Access Compliance Report

Public Rights-of-Way

(Curb Ramps)

Intersection ID: 14178	Main Street: E_8TH_ST	Cross Street: RIDGEWAY_AV	Location:	N
ADA ID: DA6425A633BA	Ramp Type: PerpDiag	Initial Pass/Fail: Fail	Overall Compliance: No	Severity Score: 12.5

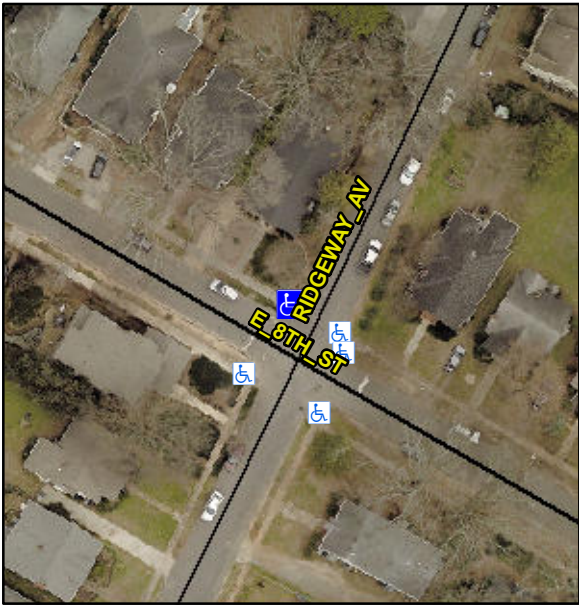
Codes/Mitigation Info/Possible Solution			Field Measurements/Component Compliance					
	Possible Solutions:		Compliance	Description	Data	Compliance	Description	Data
	Remove & Replace Curb Ramp With Two New Directional Ramps or Equivalent.		N/A	Ramp Length (in)	39.0	Yes	Ramp Slope (%)	5.4
			Yes	Ramp Width (in)	48.0	No	Ramp XSlope (%)	6.1
			N/A	Flare Type LT	N/A	N/A	Flare Type RT	N/A
			N/A	Flare Slope LT (%)	N/A	N/A	Flare Slope RT (%)	N/A
			N/A	Flare Traversable LT?	N/A	N/A	Flare Traversable RT?	N/A
			N/A	Landing Length (in)	N/A	N/A	DWS Provided?	N/A
			N/A	Landing Width (in)	N/A	N/A	DWS Contrast?	N/A
			N/A	Landing Slope (%)	N/A	N/A	DWS Length (in)	N/A
			N/A	Landing X Slope (%)	N/A	N/A	DWS Full Width?	N/A
Surveyor Notes:		N/A	N/A	Landing Curb? (Y/N)	N/A	N/A	DWS Offset (in)	N/A
PROW/ADA:		R304.5.3	N/A	Shared Landing?	N/A			
			N/A	Gutter Ponding?	N/A	N/A	Gutter Slope (%)	N/A
			N/A	Gutter Lip Ht (in)	N/A	N/A	Gutter X Slope (%)	N/A

N/A	Painted X Walk1?	No	N/A	Painted X Walk2?	No
				X Walk 1 Direction	To SW		X Walk 2 Direction	To SE
			N/A	X Walk 1 Width (in)	N/A	N/A	X Walk 2 Width (in)	N/A
				X Walk 1 Slope (%)	3.9		X Walk 2 Slope (%)	0.1
				X Walk 1 X Slope (%)	0.6		X Walk 2 X Slope (%)	5.9
Street 1 Name		E 8TH ST	N/A	Ramp inside XWalk1?	N/A	N/A	Ramp inside XWalk2?	N/A
Stop Condition-Street 2		StopSign		Road Slope (%)	5.9	N/A	Clear Space?	N/A
Street 2 Name		RIDGEWAY AV		Road X Slope (%)	3.0	N/A	Clear Space to XWalk (in)	N/A
Stop Condition-Street 1		StopSign	N/A	Any Obstructions?	N/A	N/A	Storm Grate/Utility Hazard?	N/A
				Obstruction Type			Storm Grate/Utility Type	
Total Cost:		\$ 3200.00			N/A			N/A
						Yes	Surface Condition? (G/P)	Good
